CITY OF GAHANNA, FRANKLIN COUNTY, OHIO DESIGN REVIEW PLAN FOR THE MARKET AT ROGER'S CORNERS PARKING EXPANSION 2023

Re: Roger's Market Planning Commission Materials

Subject: Project 1379-1391 E Johnstown Rd Design Review/C of A
Response Letter

In response to the comments received from City of Gahanna on February 22, 2023, the plans have been modified as described herein.

CITY OF GAHANNA, FRANKLIN COUNTY, OHIO
 DESIGN REVIEW PLAN
FOR
THE MARKET AT ROGERS'
CORNERS
SITE PLAN

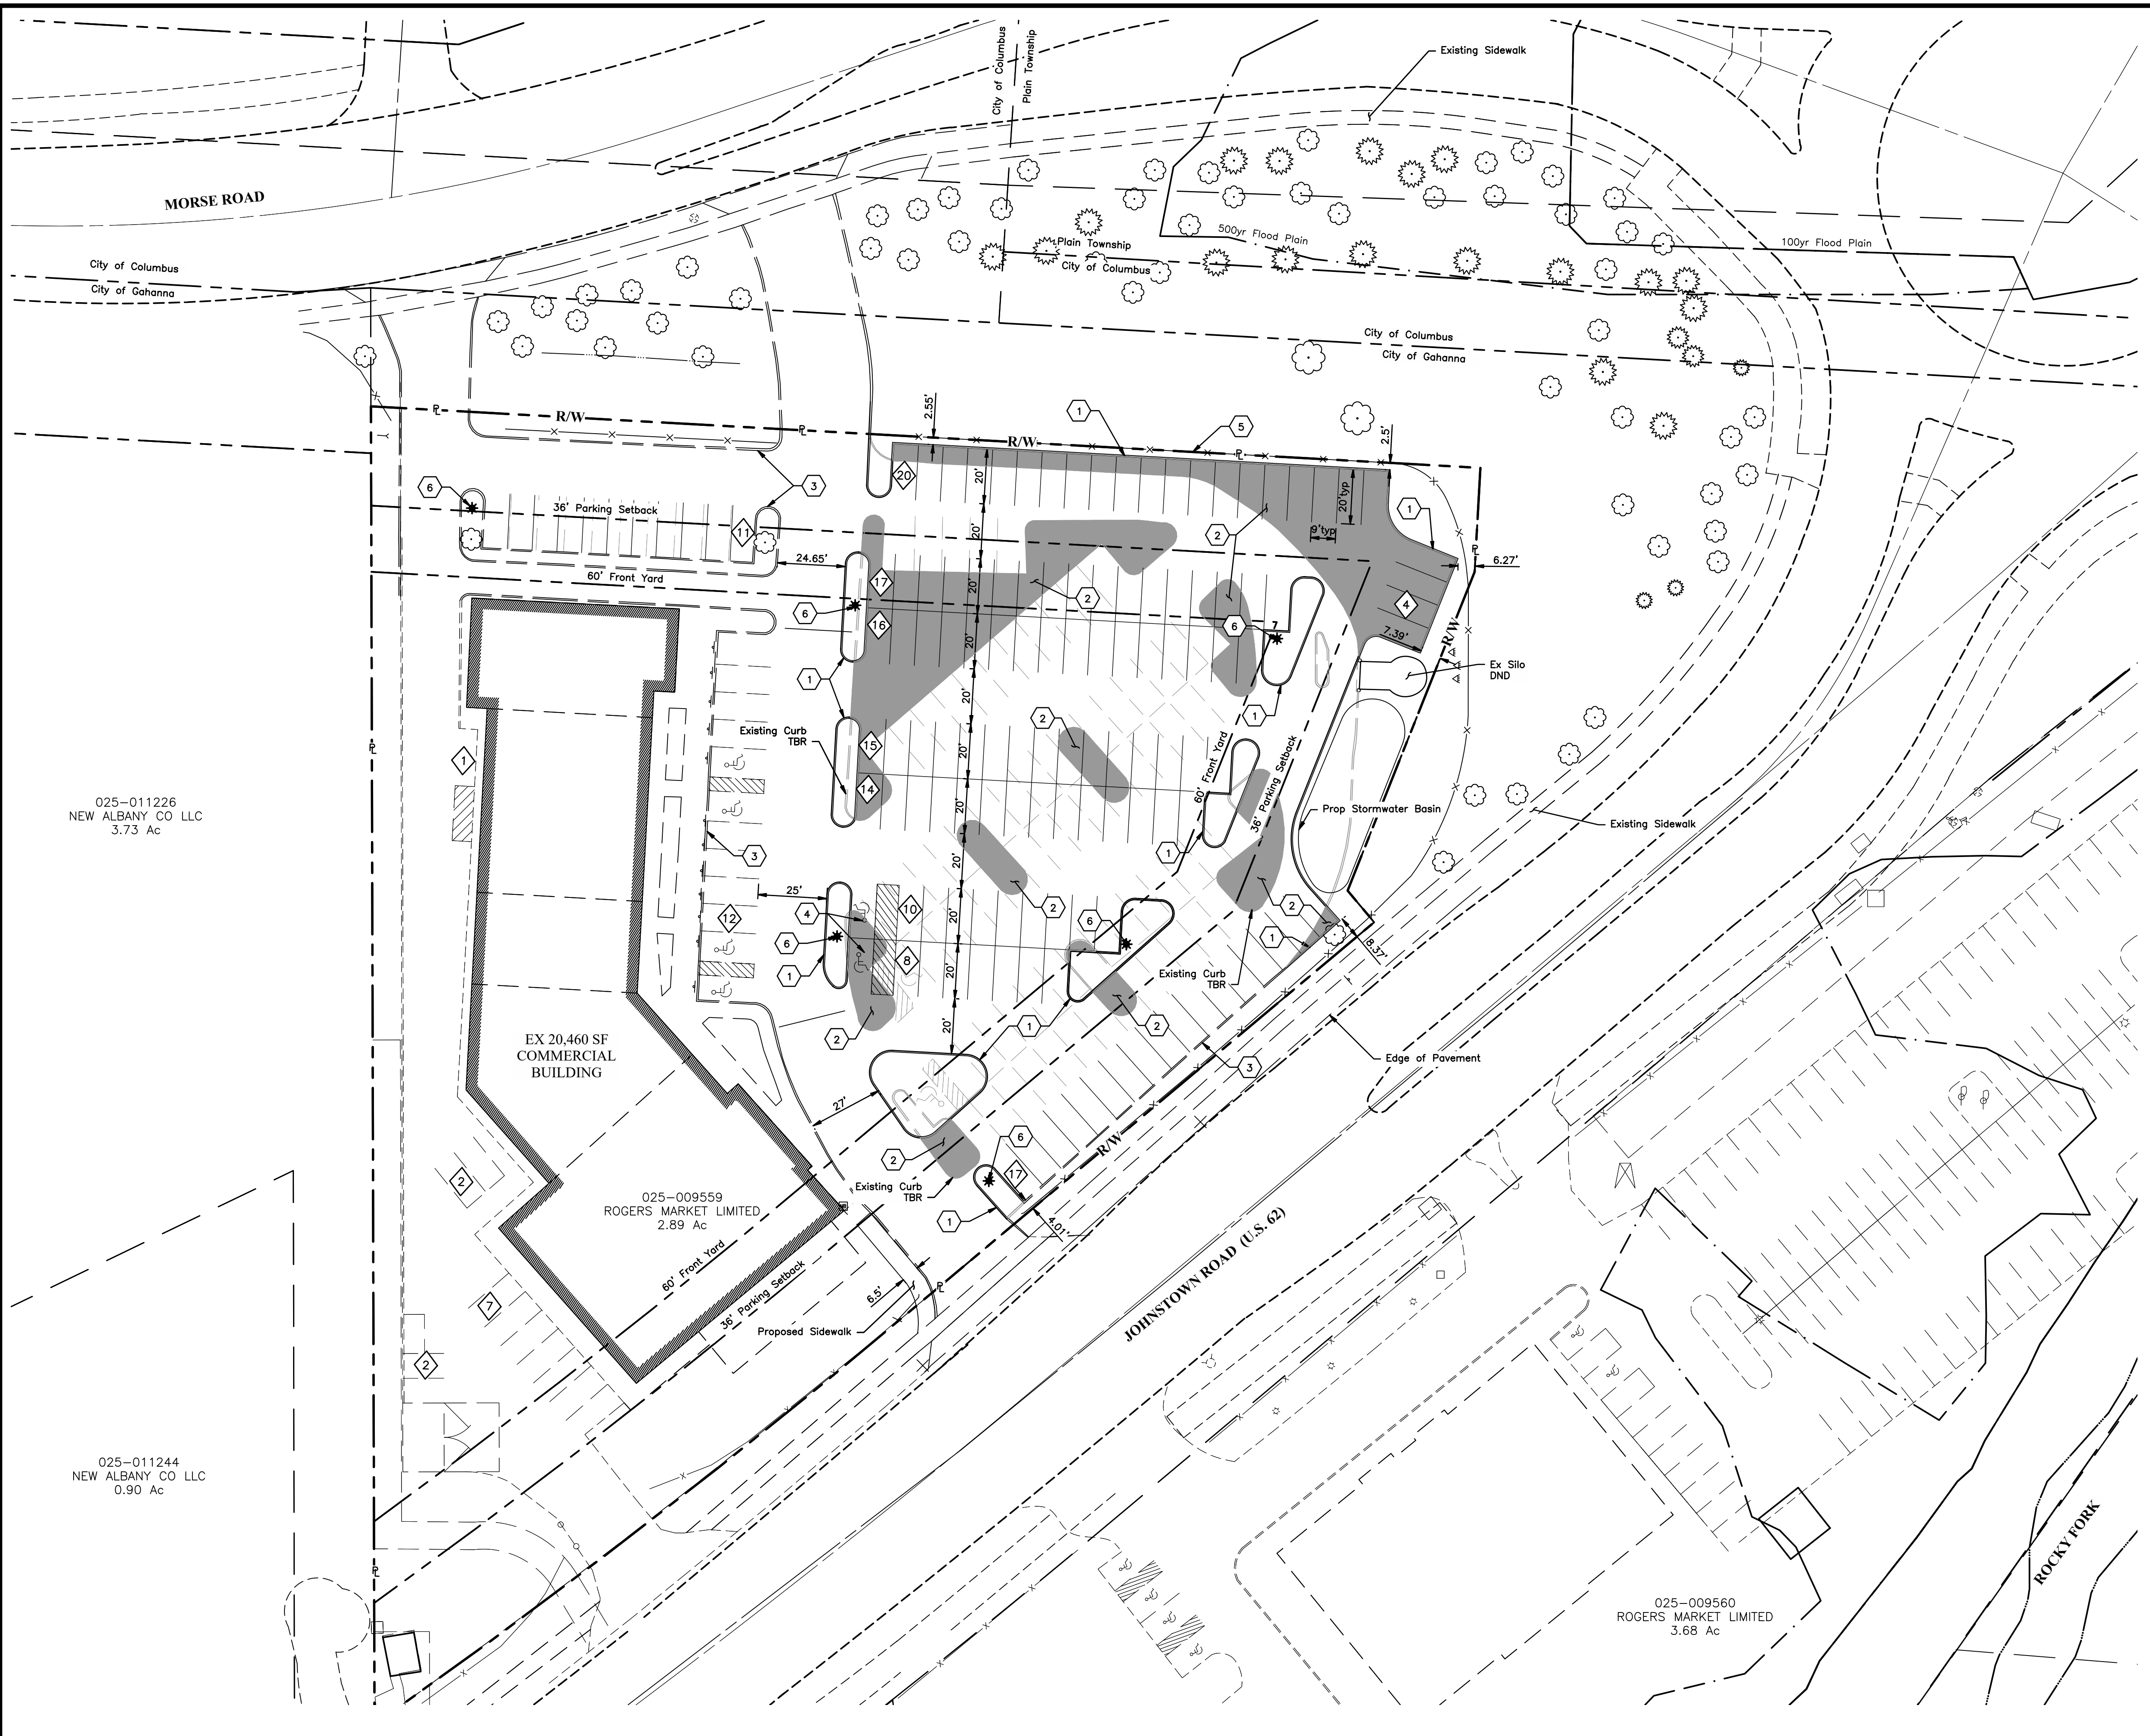
9. Include the locations of sanitary lines and water service lines in the site plan.

11. Please be aware the site plan (sheet 3/6) contains a significant amount of information that isn't approved through a design review application. Please refer to the design review application, Chapter 1197 and 1108.03 for the type of information required. For clarity, please remove the unnecessary/unapprovable information from the site plan (sheet 3/6). Please revise to clearly depict the site post development (e.g., new property lines, parking setbacks, fence location, etc.). Please be aware that additional comments may be forthcoming.

12. Chapter 1153.02/1167.15 requires a 60' front yard (north/east/south property lines) and a 36' parking setback. Please revise the site plan to clearly depict. Please revise the variance application to request a variance if necessary.

Response: Proposed sidewalk width shown on plan (sheet 3). There are no proposed sidewalk ramps.

Response: No conflict with proposed basin and existing water line. See sheet 3.

Response: No conflict with proposed basin and existing sanitary sewer. See sheet 3.

Response: Sanitary lines and water service lines shown on site plan.

Response: Unnecessary underground utilities are no longer shown on the plan. We feel the information currently on the plan is necessary to show a complete layout of the site and is pertinent to the site. New property lines, parking setbacks, and fence locations shown and called out on the site plan.

Response: 60' Front yard and 36' setback shown on site plan. Variance application has been revised and sent with the submittal package.

CITY OF GAHANNA, FRANKLIN COUNTY, OHIO
 DESIGN REVIEW PLAN
THE MARKET AT ROGERS CORNERS
 LANDSCAPE PLAN

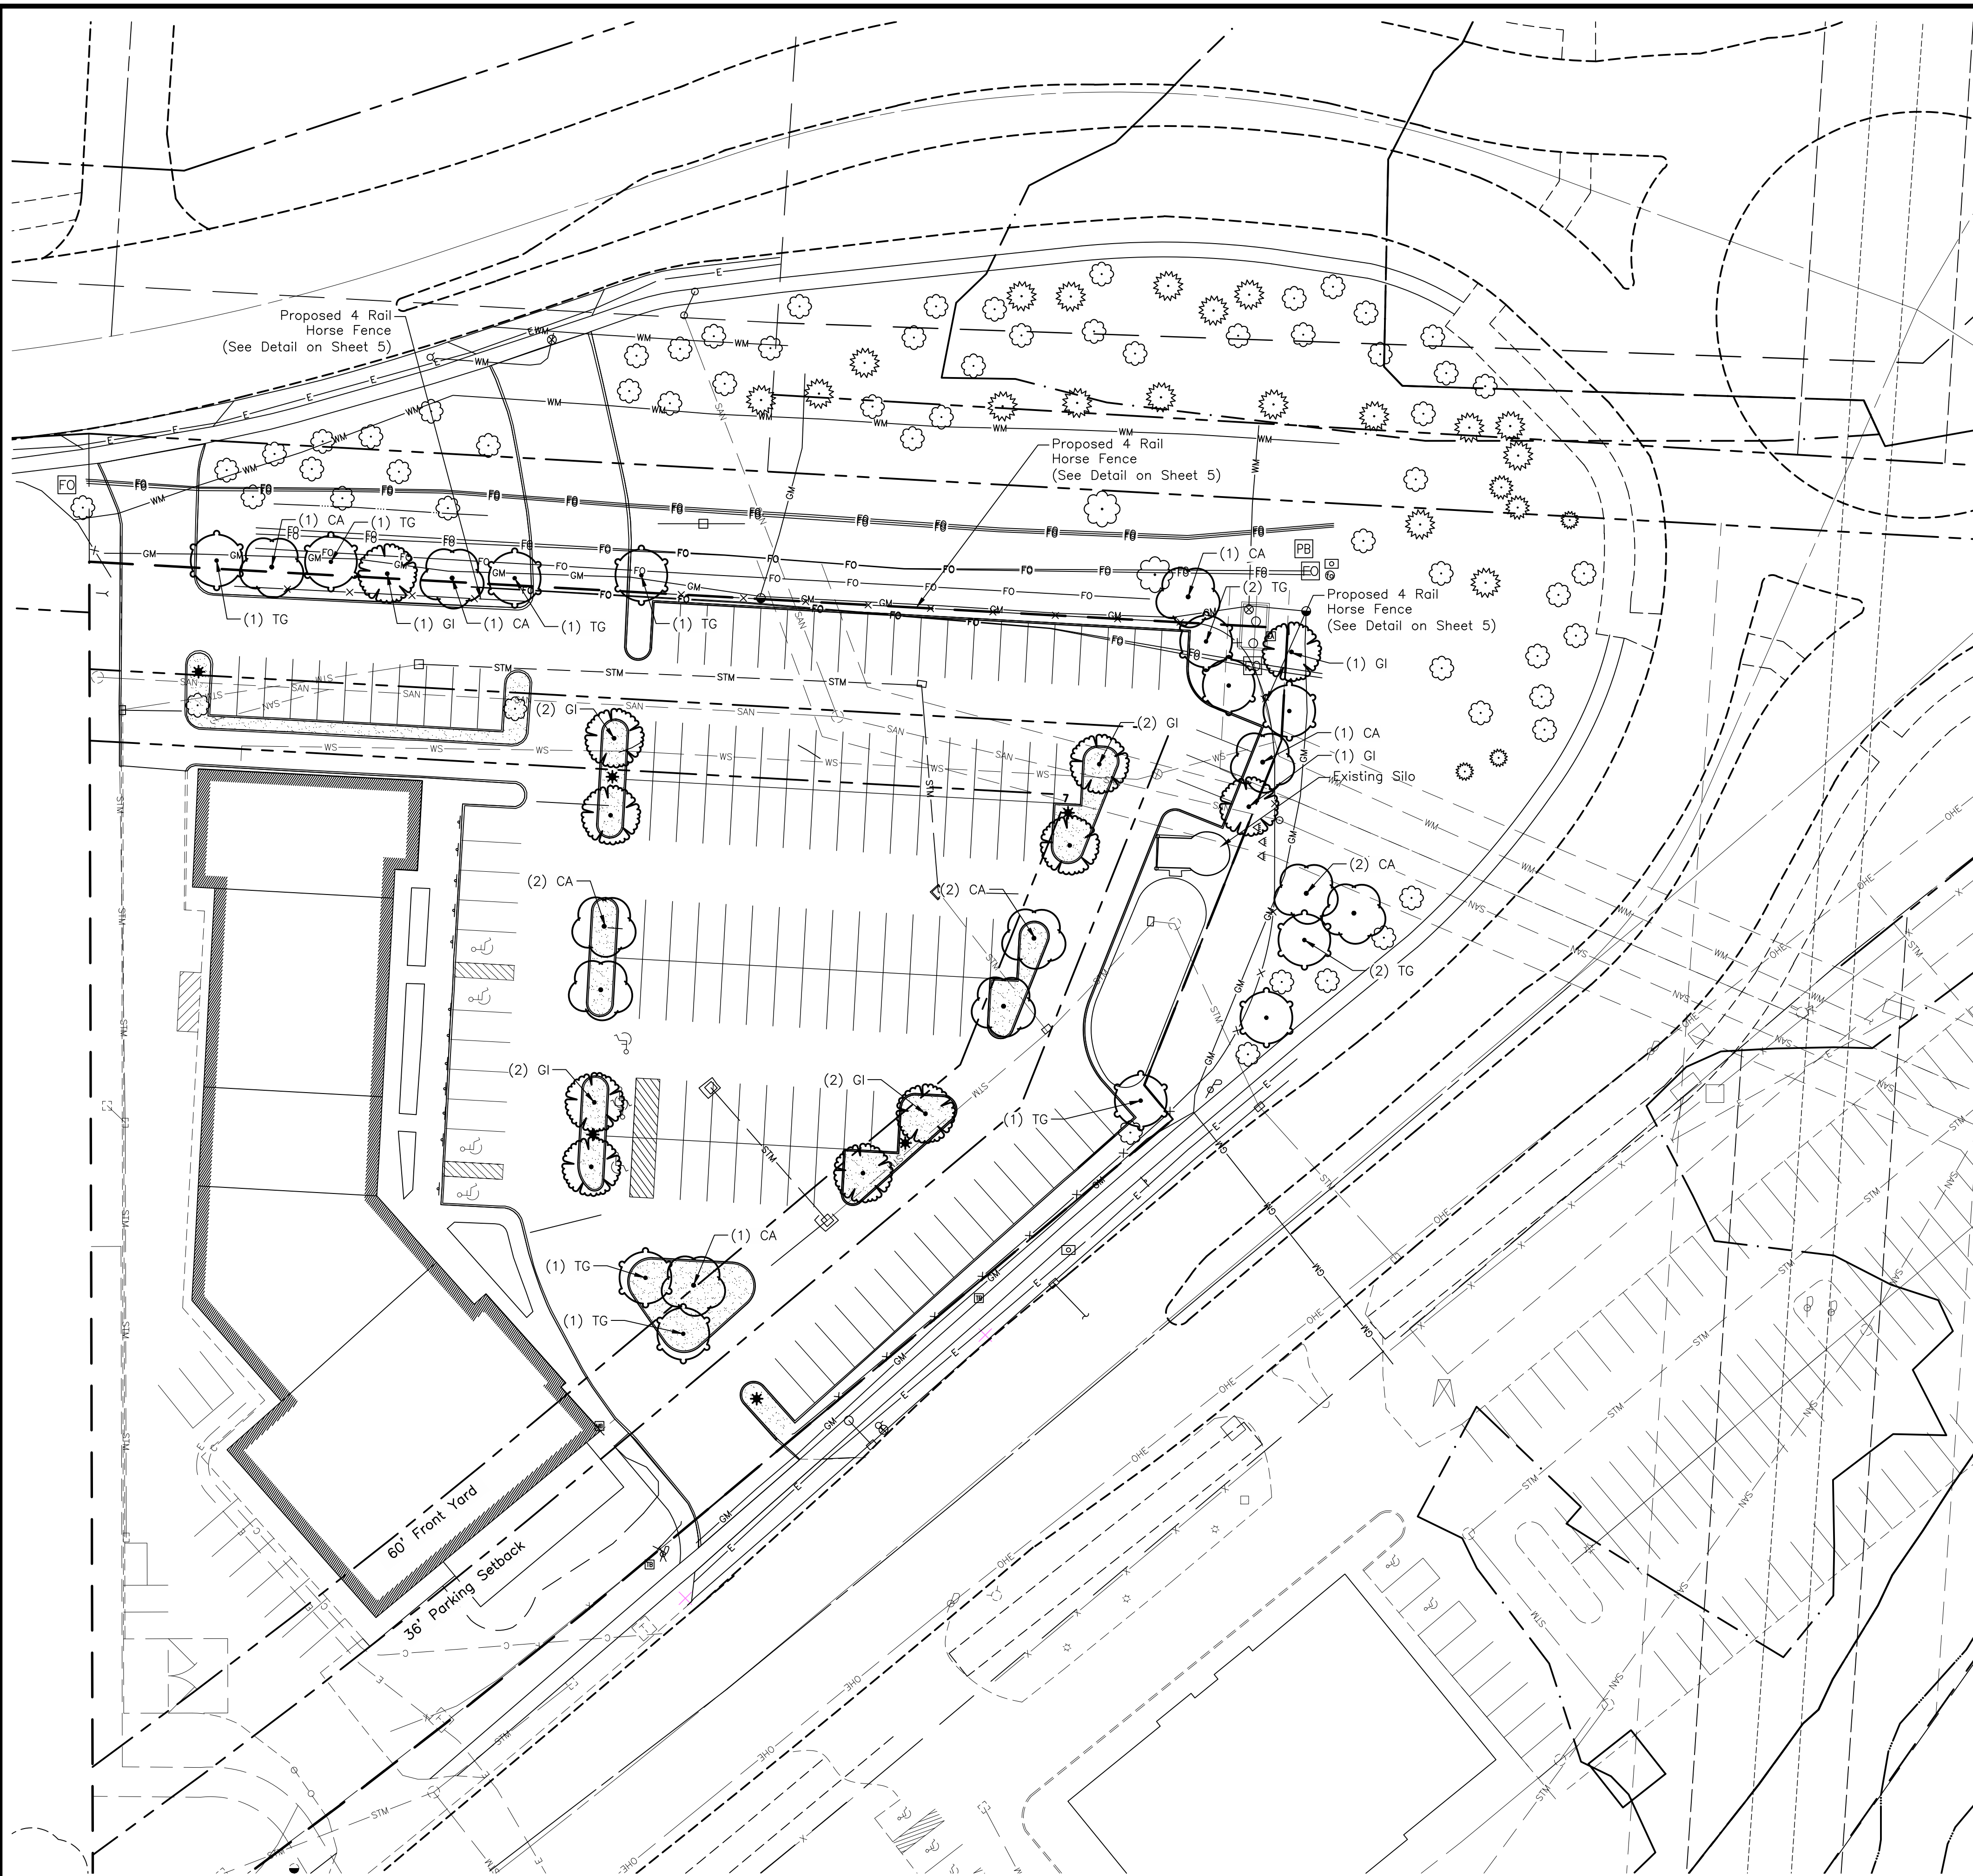
10. Landscape plans look well done. My only concern is about the choice of tree species. Honey locust and linden are both acceptable trees, but honey locusts are prone to surface roots that sometimes conflict with pavement. Lindens are prone to low hanging branches that could be difficult to keep pruned up in a parking lot setting.

14. The landscape plan contains a reference to Chapter 1155.06. Please be aware that this code requirement applies to properties zoned Office, Commerce, and Technology (OCT). Since the property is zoned Neighborhood Commercial (NC), this is not a requirement that applies to this request. The applicant may remove these landscaping improvements if desired.

3. Landscape plans look well done. My only concern is about the choice of tree species. Honey locust and linden are both acceptable trees, but honey locusts are prone to surface roots that sometimes conflict with pavement. Lindens are prone to low hanging branches that could be difficult to keep pruned up in a parking lot setting.

Response: Tree species listed are part of the approved trees by city of Gahanna and have small leaves that will better minimize debris in the parking lot during the fall.

Response: Landscaping requirements pertaining to 1155.06 removed from plan.
